261M COIL, MAGNET ASSEMBLY

TP148128 AND TP159597 FLAT WASHERS,
TP149938 SHOULDER SCREW, TP149939 SPRING WASHER
TAPE SUPPLY REEL ASSEMBLY AND TAPE REPERFORATOR CABINET

SECTION 592-806-800.02

**TP149974 MERCURY SWITCH,
TP309512 AND TP309899 SPARK SUPPRESSION NETWORKS**

Figure 1

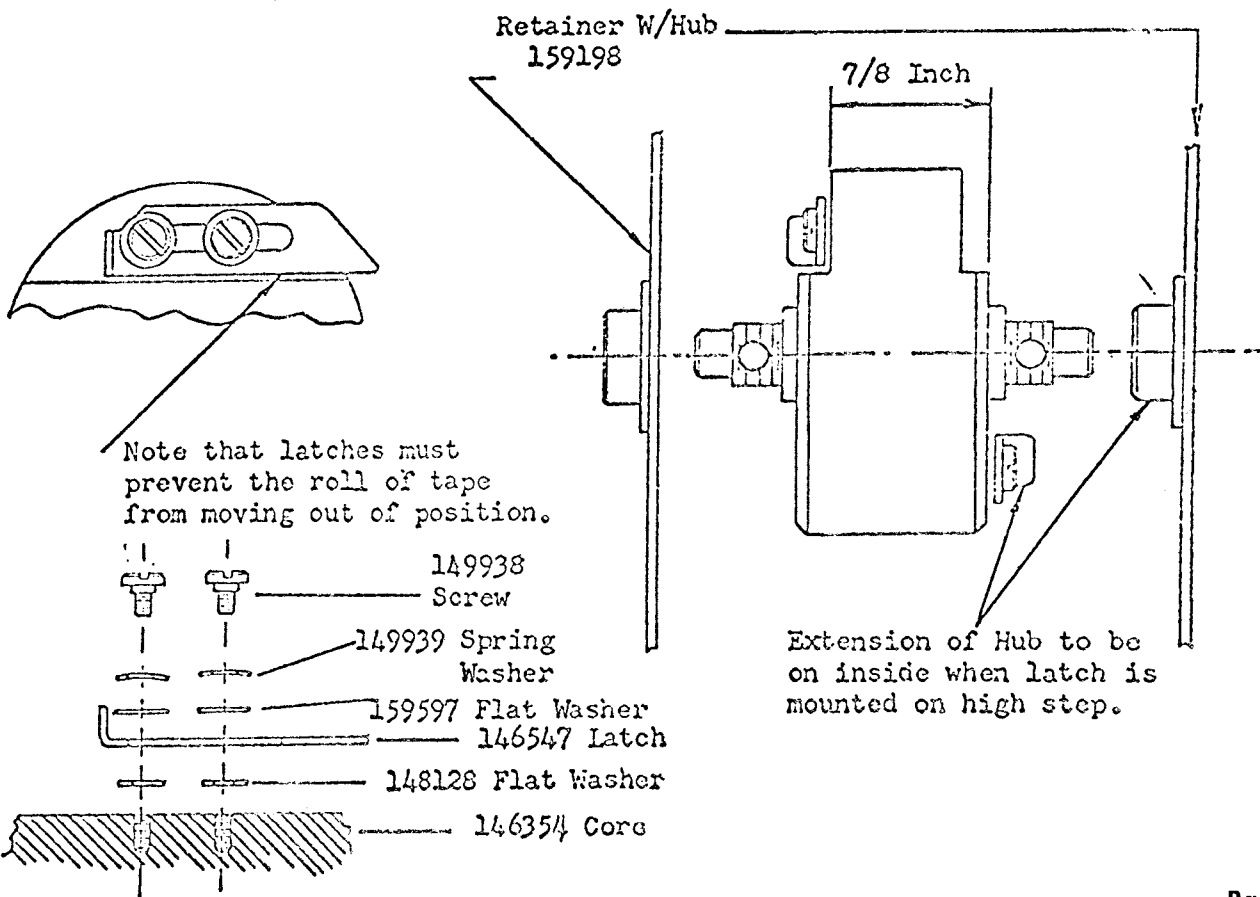
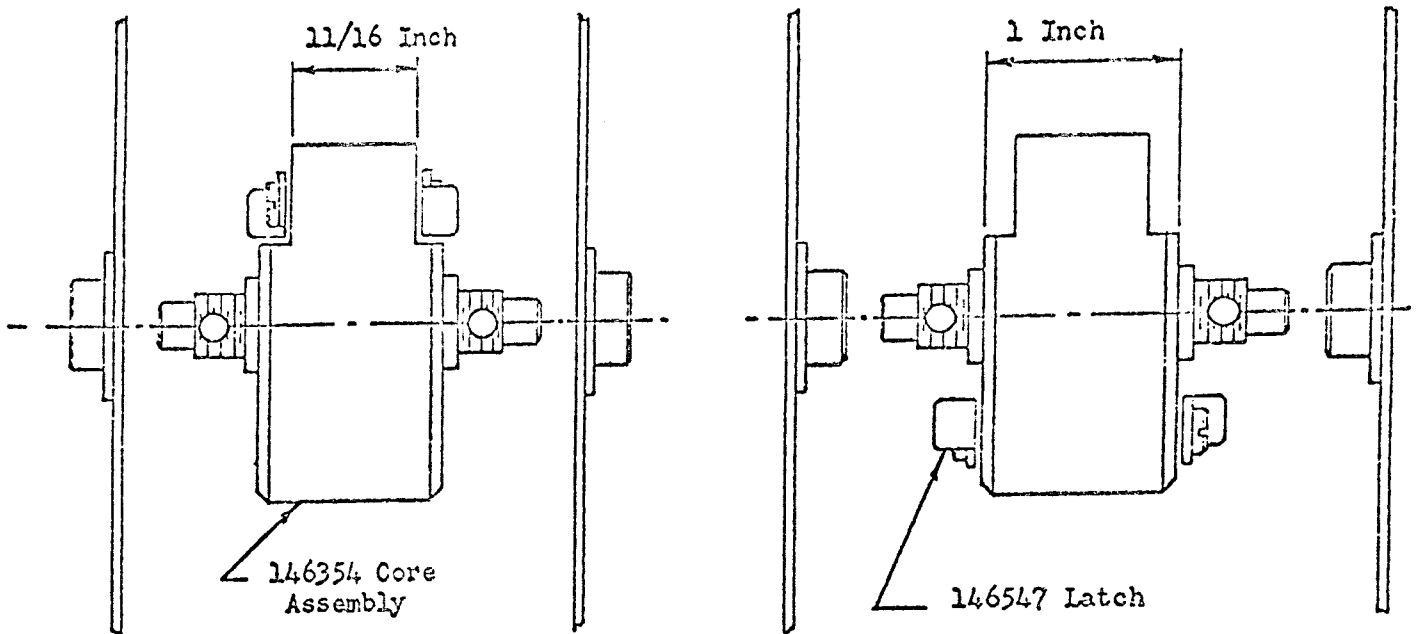
OBJECT: To provide an improved design of the tape reel core latch assembly. To forward information on the recommended assembly procedure for the tape supply reel of DATASPEED reperfector cabinets to accommodate various widths of paper tape. To eliminate tape tearing and erratic loadings on the roll of paper tape.

CHANGE: New style parts and additional parts have been added to the tape supply reels as follows:

- (a) The TP110334 shoulder screw (4-40 x .272 inches) has been replaced by a TP149938 shoulder screw (4-40 x .291 inches).
- (b) The TP89406 spring washer (.312 O.D. x .144 I.D. x .010 thick with a .018 bow) has been replaced by a TP149939 spring washer (.312 O.D. x .144 I.D. x .006 thick with a .030 bow).
- (c) Two TP159597 flat washers have been added to the latch assembly on each side of the TP146354 core assembly.
- (d) Two TP148128 flat washers have been added to the latch assembly on each side of the TP146354 core assembly.

Figure 1 illustrates the assembly of the new and added parts and the method of tape reel assembly to accommodate rolls of paper tape having tape widths of 11/16 inch, 7/8 inch and 1 inch.

INTERCHANGEABILITY: New style and old style core assemblies are interchangeable. New and old style parts are not individually interchangeable but are interchangeable in sets.
